Department of Conservation and Development

County Planning Commission

STAFF REPORT **Agenda Item #____**

Project Title:	Camino Pablo Single-Family Residential Subdivision, Rezone, General Plan Amendment and Development Plan
County File:	CDSD23-09646, CDRZ23-03270, CDGP21-00004, CDDP23-03012
Applicant	Benoit McVeigh, dk Engineering
Owner(s):	Dobbins Properties, LLC
Zoning/General Plan:	A-2, General Agricultural District / AL, Agricultural Lands
Site Address/Location:	0 Camino Pablo (immediately east of Tharp Avenue intersection), in the Moraga area of unincorporated Contra Costa County (APN: 258-290-029)
California Environmental Quality Act (CEQA) Status:	Mitigated Negative Declaration, SCH 2024110934
Project Planner:	Adrian Veliz, Senior Planner (925) 655-2879 adrian.veliz@dcd.cccounty.us
Staff Recommendation:	Approve (See Section II for Full Recommendation)

Figure BIO-1

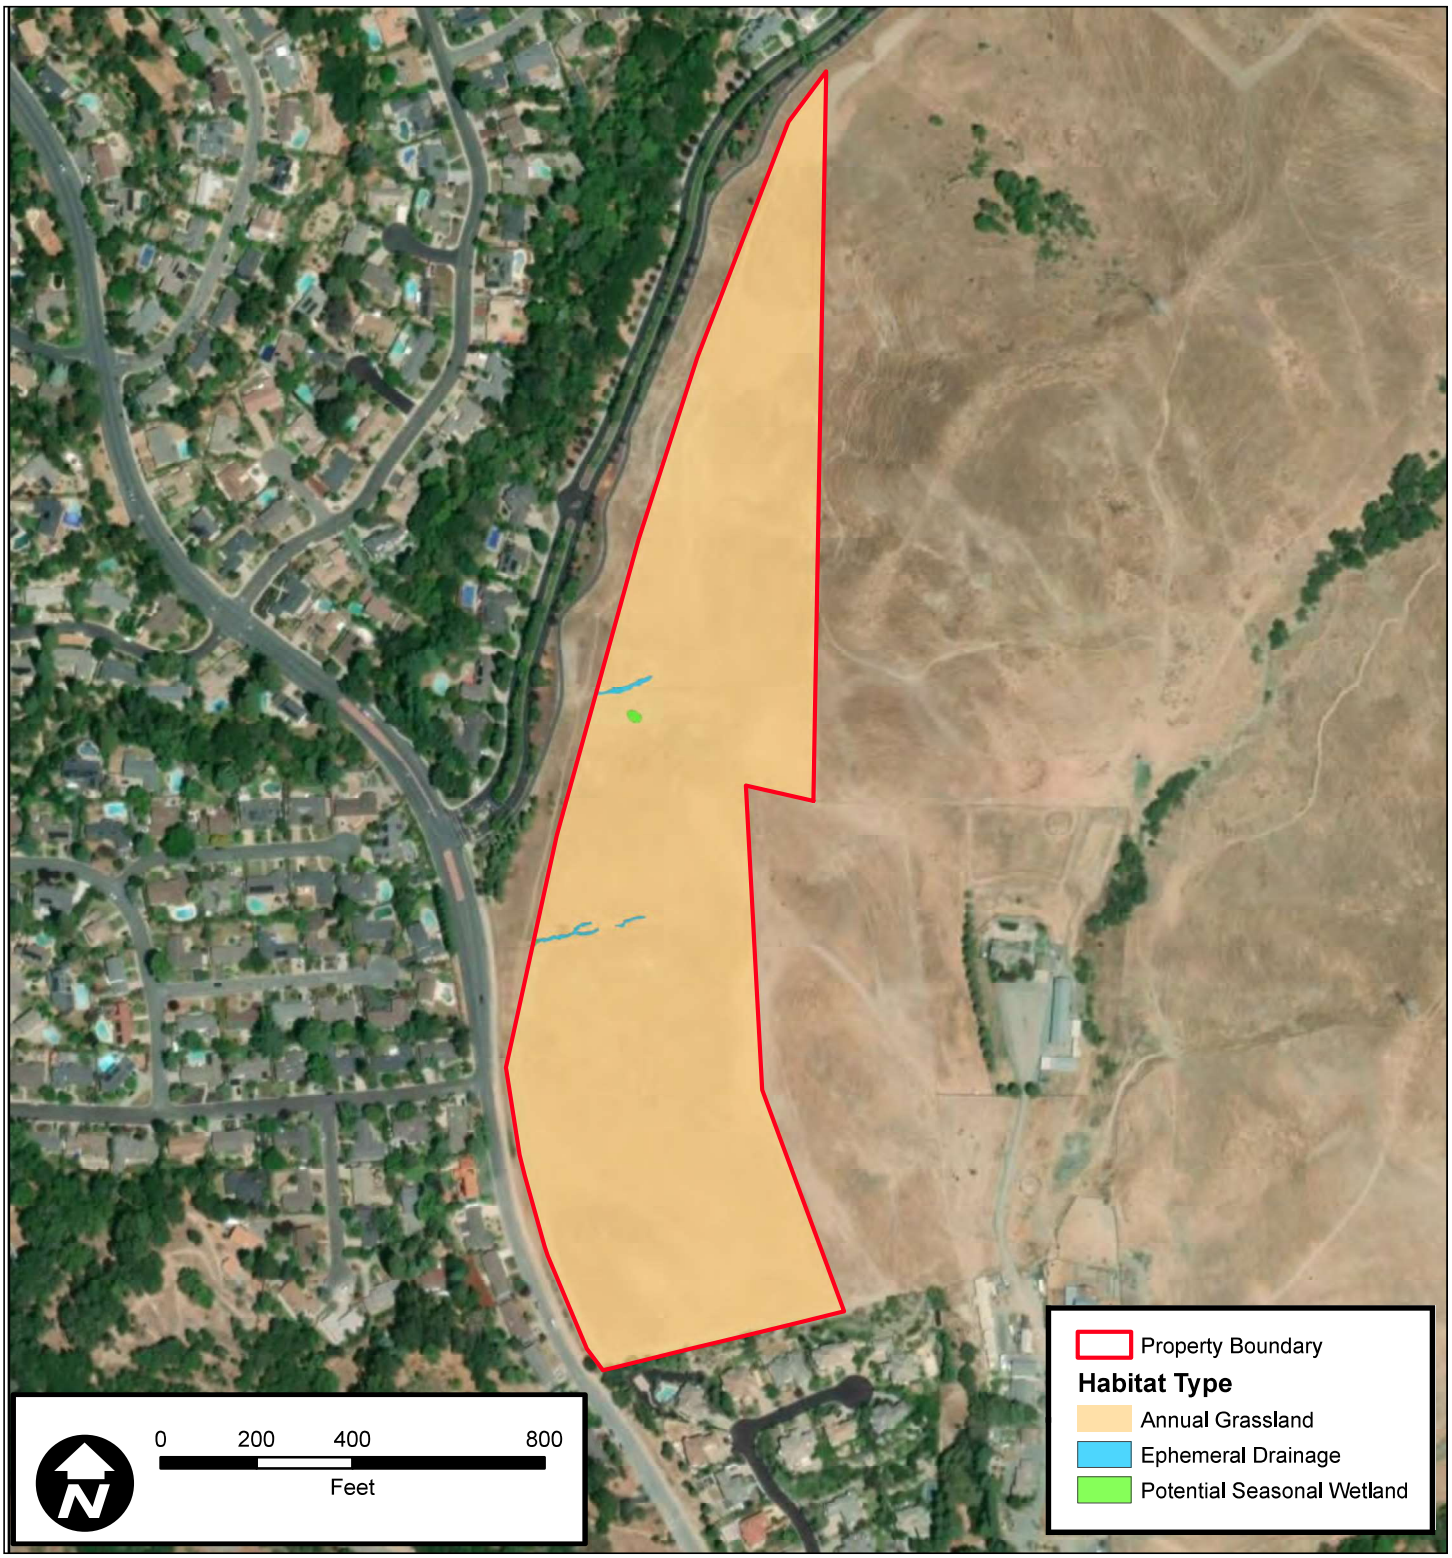
Comment 2.i: The Draft IS/MND does not include critical analysis or mitigation of the substantial nuisance and other effects to existing sensitive receptors within the immediate project vicinity.

Response: All of the habitats on the project property have been mapped and are depicted on Figure BIO-1 in the IS/MND. As shown on the figure, the site does not support oak savanna, oak-bay woodland, mixed evergreen forest, riparian habitat, or rock outcrop features, though it is dominated by annual grassland. The IS/MND acknowledges that Alameda whipsnake (AWS) could be present on the project site due to its location within Critical Habitat (Unit 2) designated for the species by the U.S. Fish and Wildlife Service (USFWS). However, it is unlikely to occur due to the prolonged, intense grazing that has been occurring on the site for many decades. This activity keeps the height of the grasses and weeds very low and, as a consequence, the vegetation does not provide suitable protection and coverage from AWS predators, nor does it provide shade for critical temperature regulation.
